**Re: Supplemental Work Plan Addendum  
Green Valley Citgo  
11791 Fingerboard Road  
Monrovia, Maryland  
MDE Case # 2005-0834-FR**

### **SUBSURFACE INVESTIGATION WORK PLAN ADDENDUM**

**PROPOSED WELL LOCATION MAP**

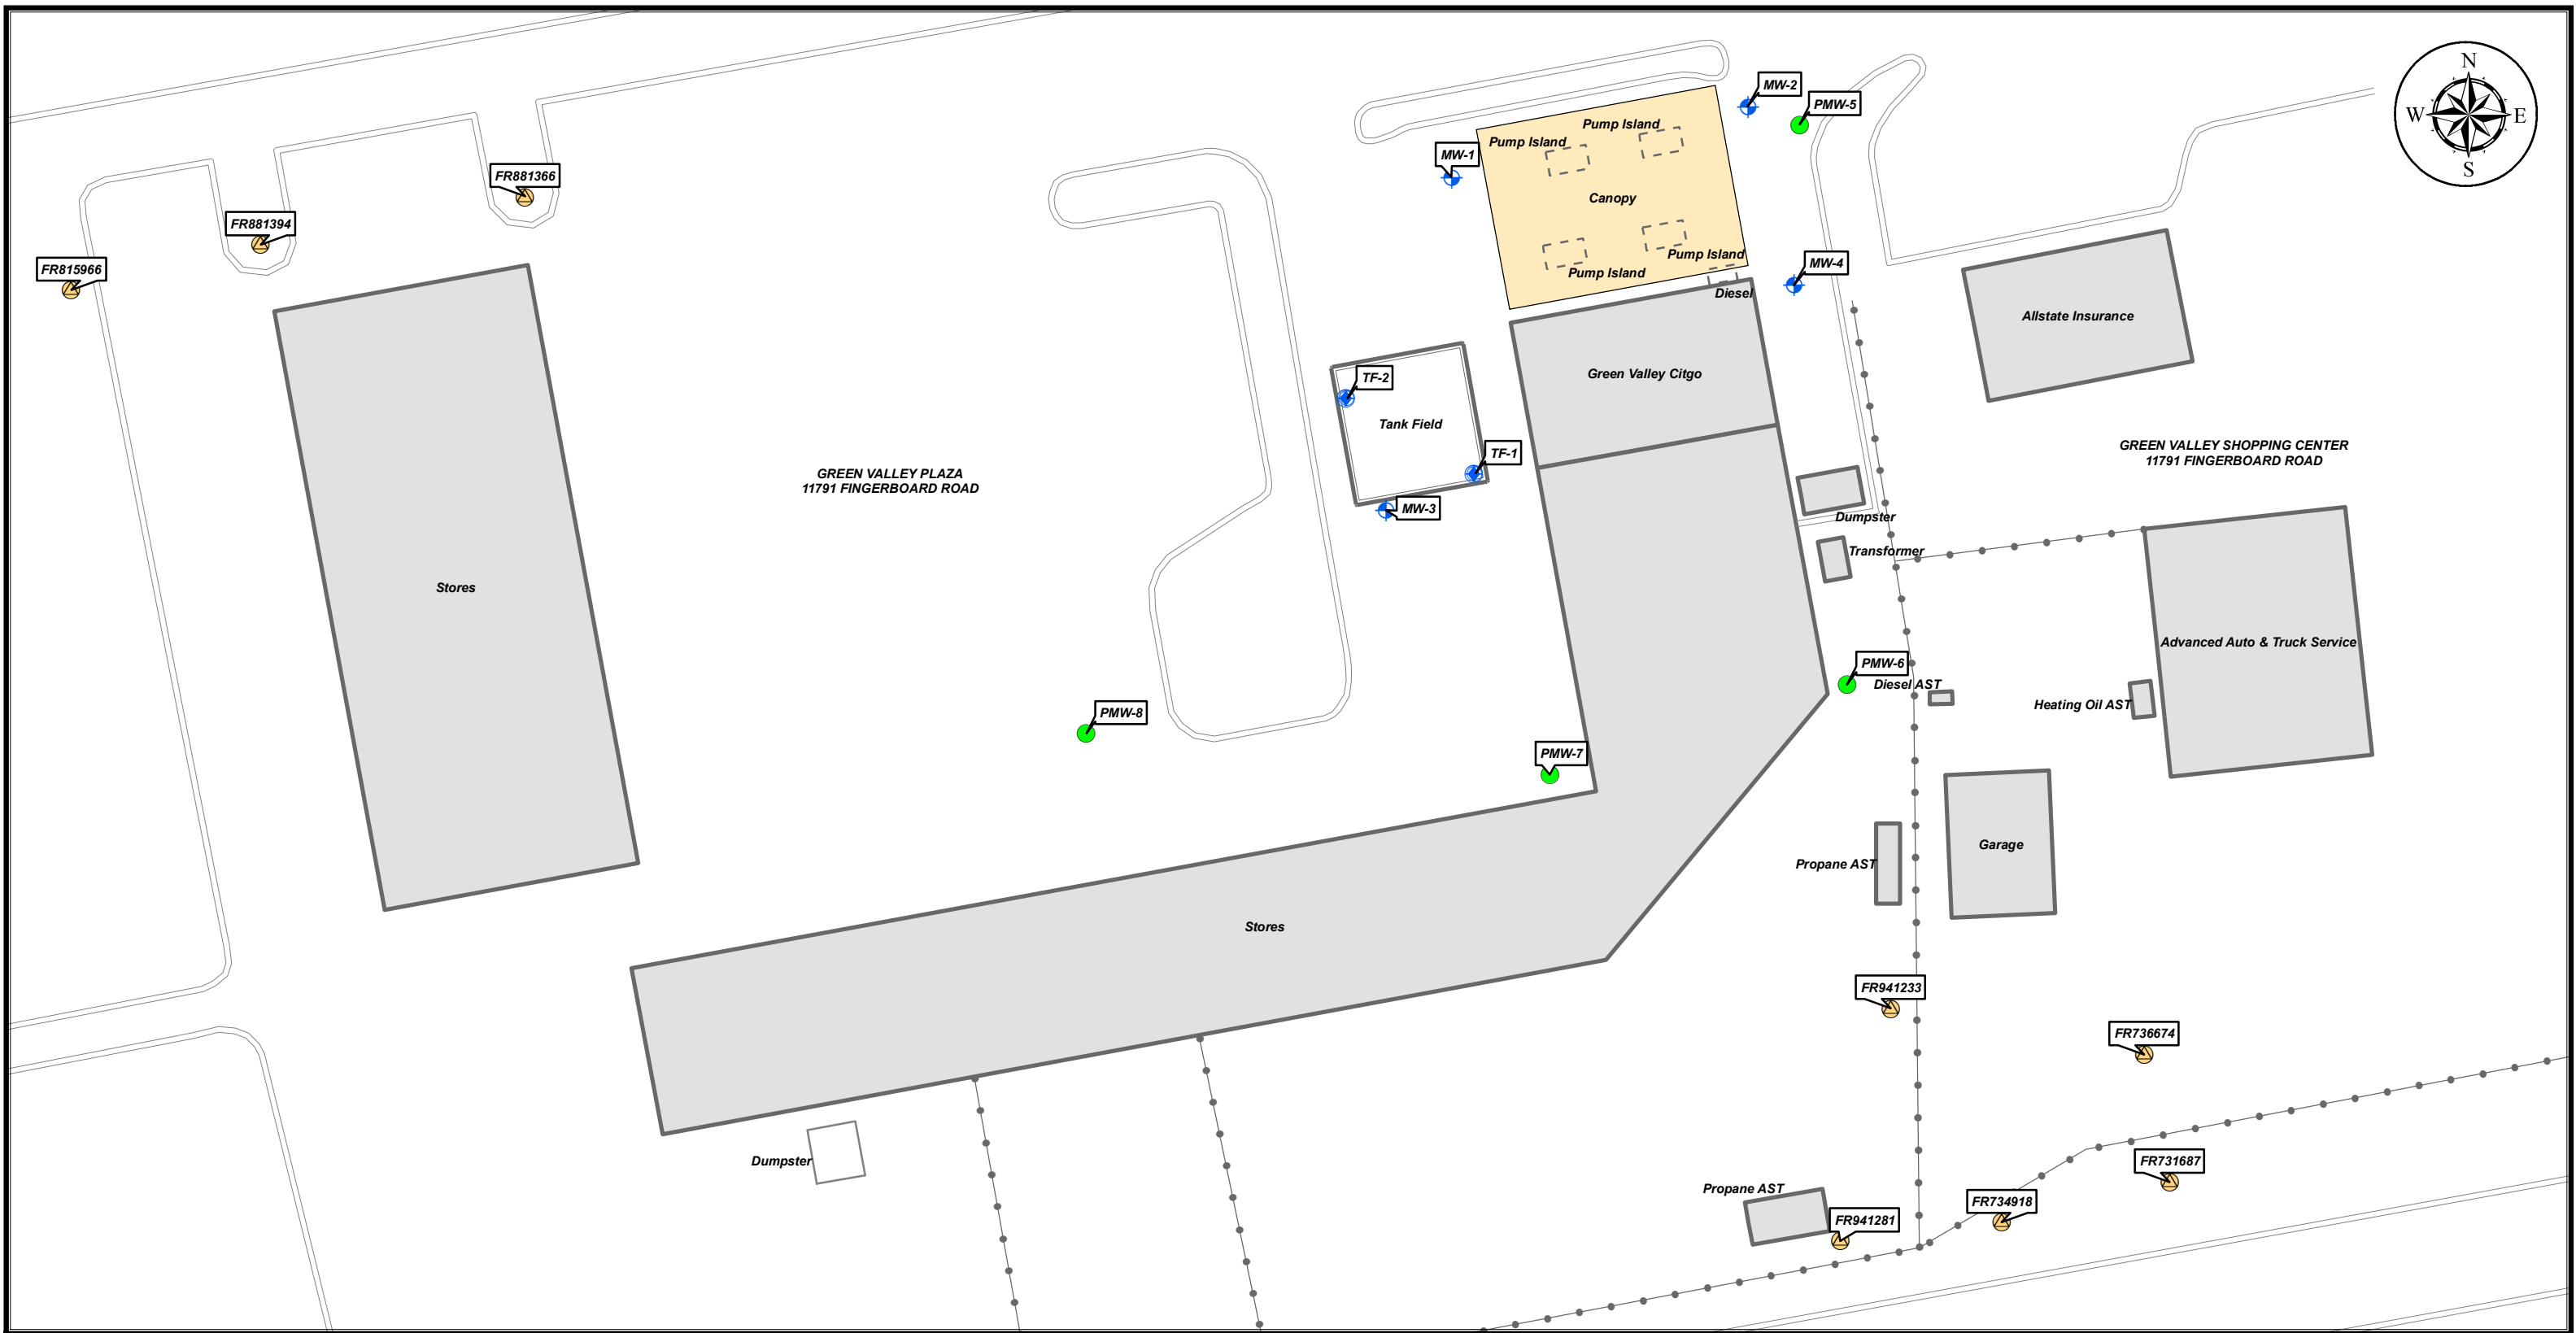
The proposed addendum to the work plan included mobilization with an air rig to install the four proposed shallow monitoring wells to a maximum depth of 60-feet below grade surface (bgs). The monitoring wells will be drilled to a sufficient depth to intercept first groundwater beneath the site. In order to properly seal off the top portion of the overburden, to prevent caving, the upper portion of the monitoring wells will be constructed using steel casing. The air rotary drill rig will first be equipped with a nominal twelve-inch drill bit to drill a twelve-inch borehole to a depth between eight and ten feet below ground surface (bgs). Eight-inch diameter, 3/8-inch thick steel casing will be fitted with a drive shoe and installed to the total depth of the initial borehole.
